RE: St. Laurent Lagoon Assessment
Notice of Alteration - Sandy Bar Road Wastewater Treatment Facility

LAGOON ASSESSMENT
ST. LAURENT, MANITOBA

SITE PLAN		REV: A
NOVEMBER 2015	FIGURE 01

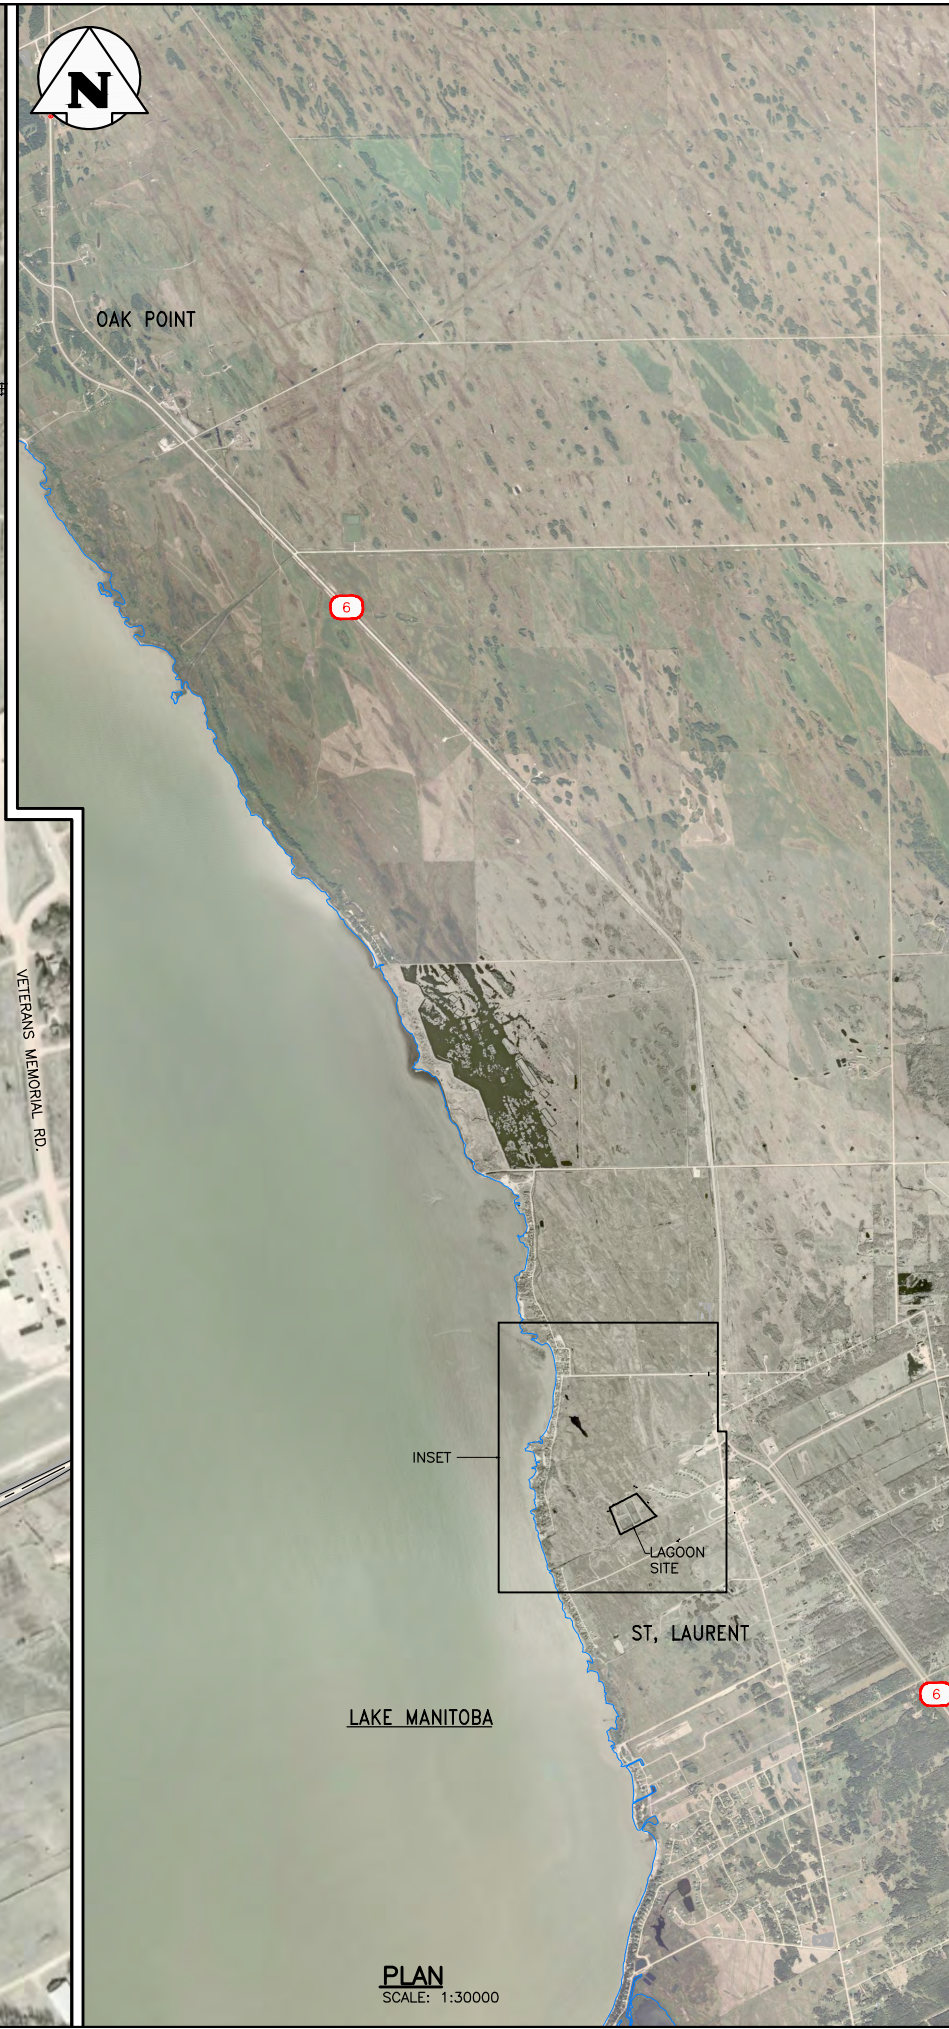
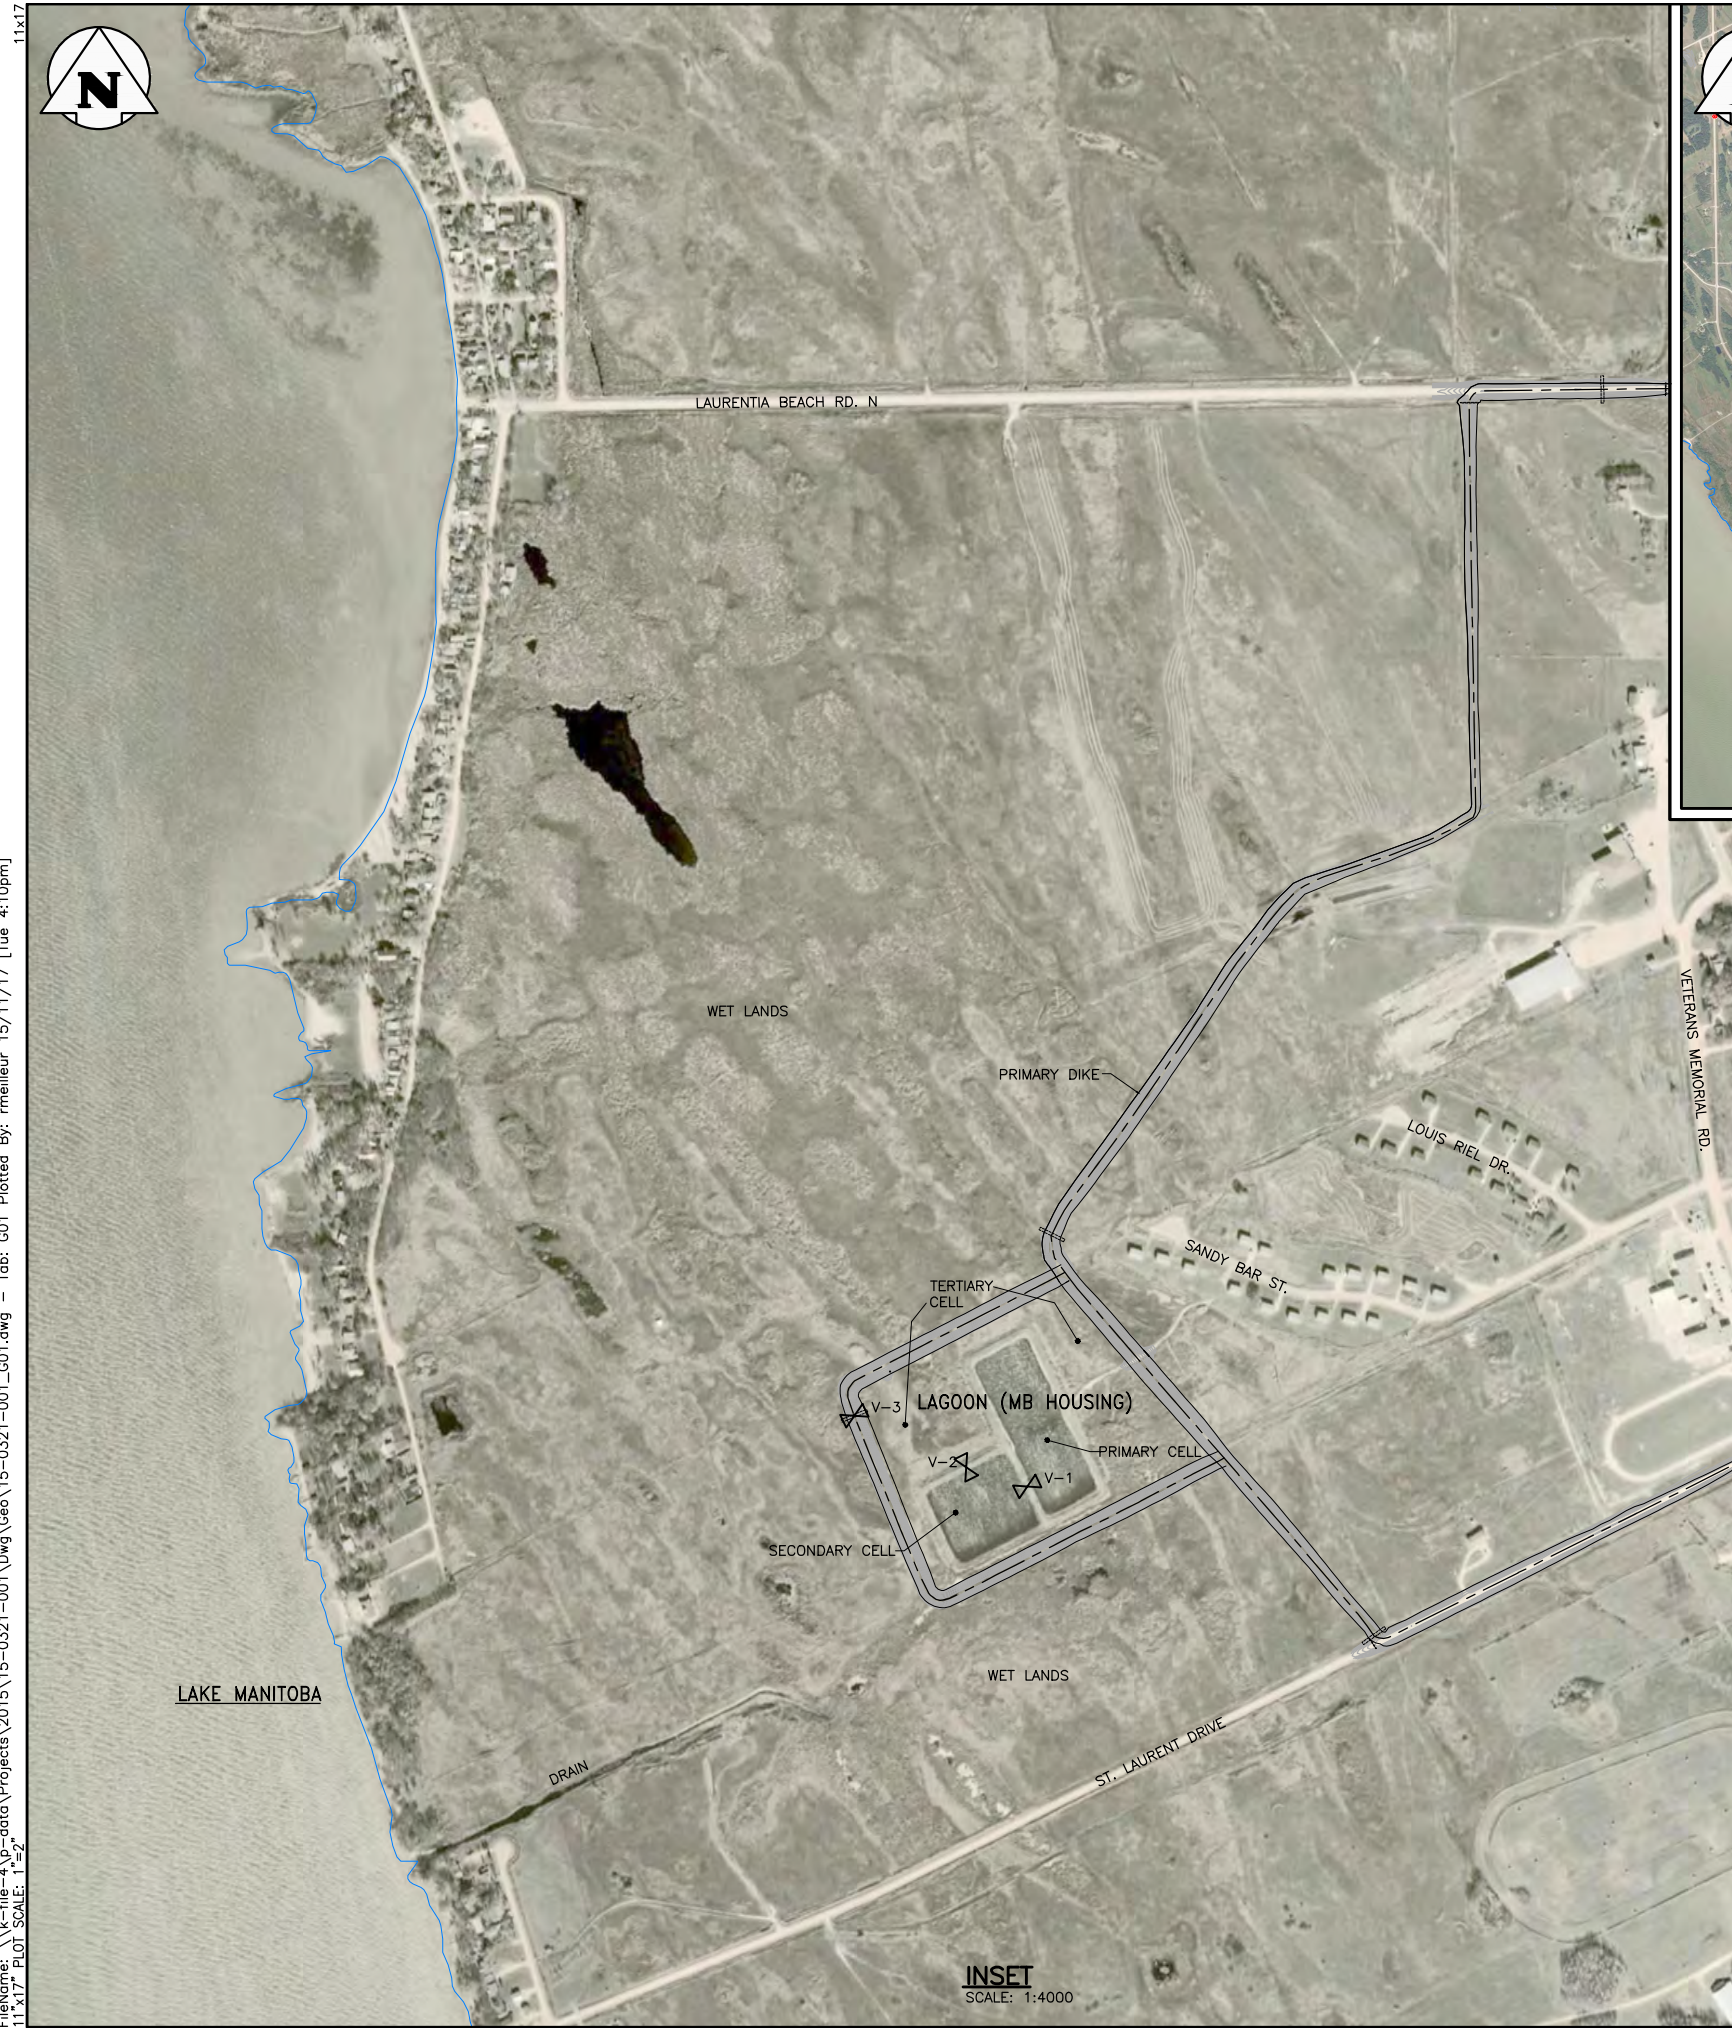
It is proposed that the area between the flood protection dike and the existing cells be used as a Tertiary Cell for further polishing of effluent before surface release occurs. This can be accomplished by installing a new interconnecting valve on the Secondary Cell of the lagoon and converting the culvert through the flood protection dike to a valve. The location of the new valves will be documented and marked within the facility. By introducing a Tertiary Cell, the capacity of the facility will be doubled for an approximate total capacity of 43,000 m³.

The February 26, 2015 letter from MCWS indicated that the interconnecting valve between the Primary Cell and Secondary Cell needed to be checked for functionality. It has been confirmed that this valve is not currently operational and the other valve could not be located. Both of these valves will be replaced, and the locations will be documented and marked within the facility. A third valve will be adapted into the current culvert to allow discharge from the Tertiary Cell to the marsh area.
